## **Additional Information and Preferred Project Report**

Mod 2 to MP 09\_0209

396 Lane Cove Road & 2 Coolinga Street,  
Macquarie Park

03 July 2018 | 17164

**Figure 1** Ground Floor of the approved Concept Plan

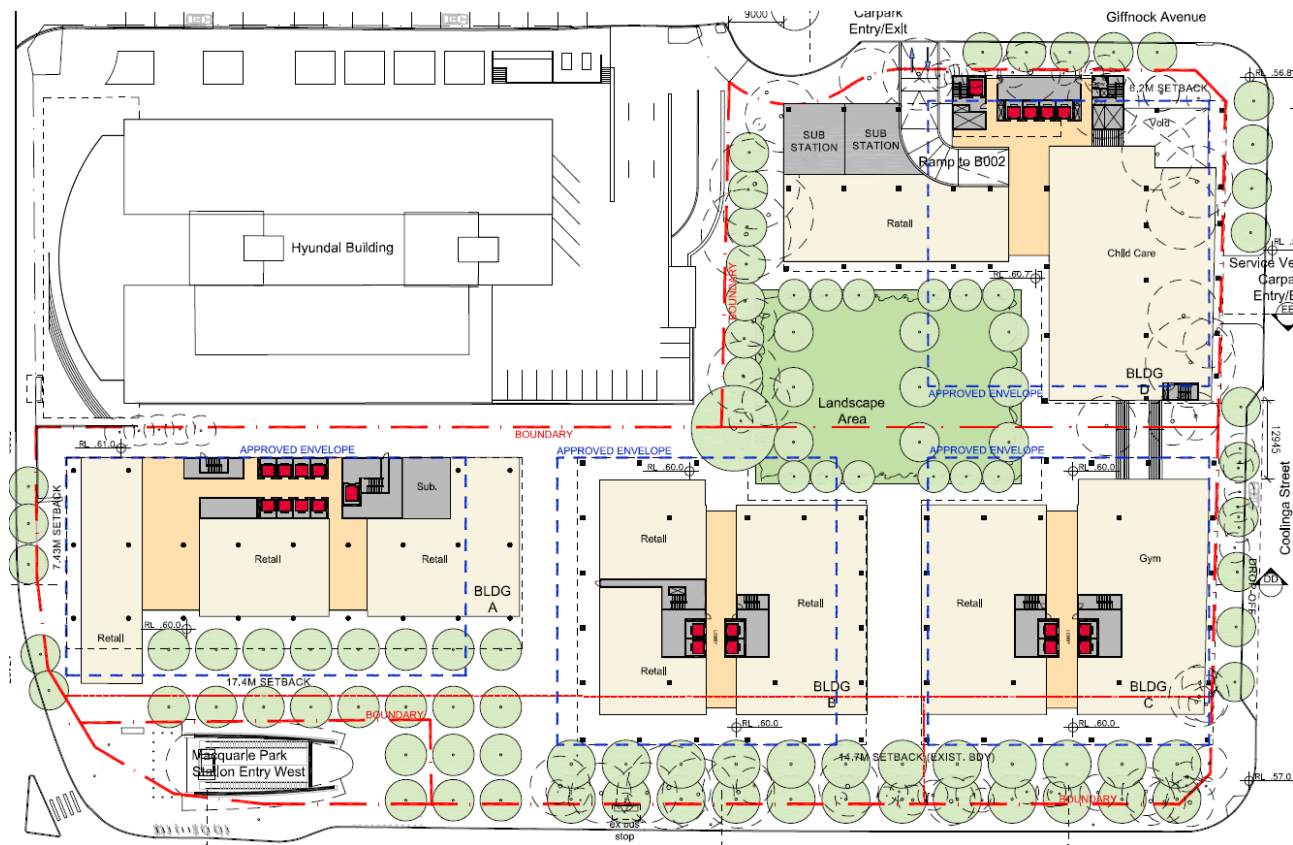
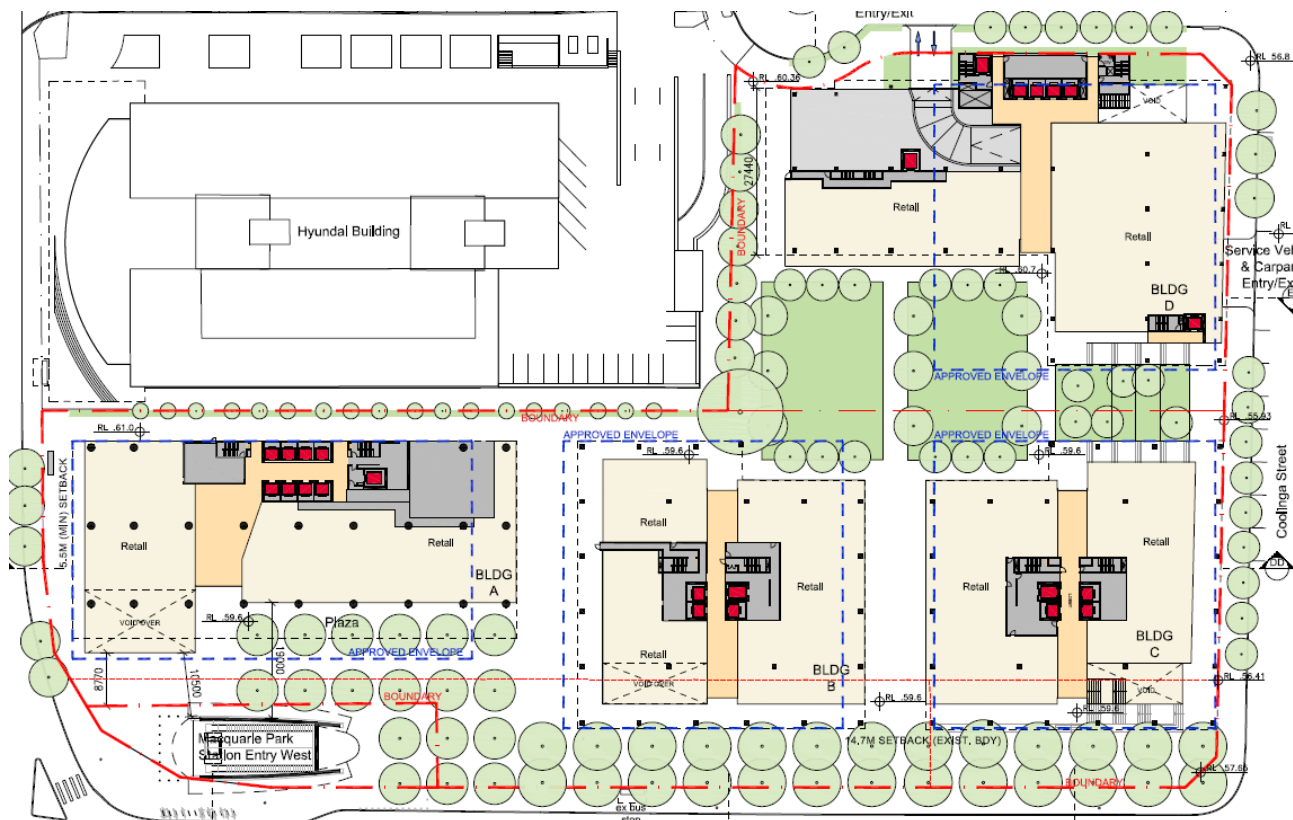
- approved Concept Plan (**Figure 1**);
- proposed Concept Plan that consent was originally sought for in February 2018 (**Figure 2**); and
- amended Concept Plan that is the preferred project for the site (**Figure 3**).

The proposed building envelopes have been amended to increase the width between buildings A – B and B – C by 1m at both ground and upper levels, and increase the distance between buildings C – D by 6.66m at ground level and 3.5m at the upper levels. This improves the separation between buildings, whilst still retaining the activated and intimate laneway scale that is essential to the success of the site as a new destination within Macquarie Park.

The length of Building A has also been reduced by 2m, thereby lessening the bulk and mass of the building as viewed from Waterloo Road. The detailed design of Building A within this maximum building envelope will be the subject of a separate and future Stage 2 Development Application, which will test and develop the architectural treatment including the composition, articulation and materiality of the building to ensure it does not create any unacceptable visual or amenity impacts.

The amended Concept Plan increases the width between buildings to the following.

Buildings	Ground Level	Upper Level
A – B	13.15m	10.00m
B – C	10.00m	10.00m
C – D	19.6m	12.50m

**Figure 5** Approved open space area and path of travel from Giffnock Avenue

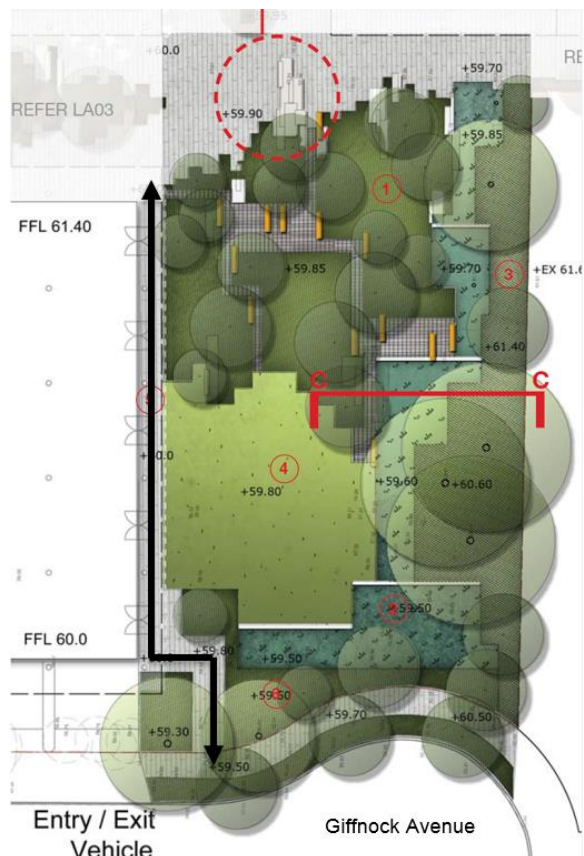
An issue was raised with the location of the proposed open space area for reasons of privatising the space, its contribution to the street network, and the activation of the Giffnock avenue frontage. Accordingly, the UDRP panel encouraged the proponent to explore an extension of the park to Coolinga Street with a wider throat between Buildings C and D of 10-15m, noting that this would provide a clearer link and address for the park and a more generous solar corridor to reduce the extent of overshadowing.

- The open space area is significantly increased in size (by 774m<sup>2</sup> from the CPA, and 324m<sup>2</sup> from the original Modification Application) and will provide usable and trafficable space with outdoor dining, large areas of turf for informal seating/recreation and shade trees (see Error! Reference source not found. and **Figure 7** below).

This is a clear improvement on the open space configuration approved under the Concept Plan, which creates a scenario where open space is fragmented, poorly integrated, and primarily located at the rear of the site, away from the key Waterloo Road frontage and is therefore uninviting to the public.

This has been achieved in the amended design, which seeks to provide an extended park to Coolinga Street via a wider opening between the building envelopes. This increases the overall quantum of open space being provided (by 50% from the Concept Approval and 15% from the original Modification Application) whilst also improving both the visibility of, and solar access to, this space (see also **Section 3.2** below).
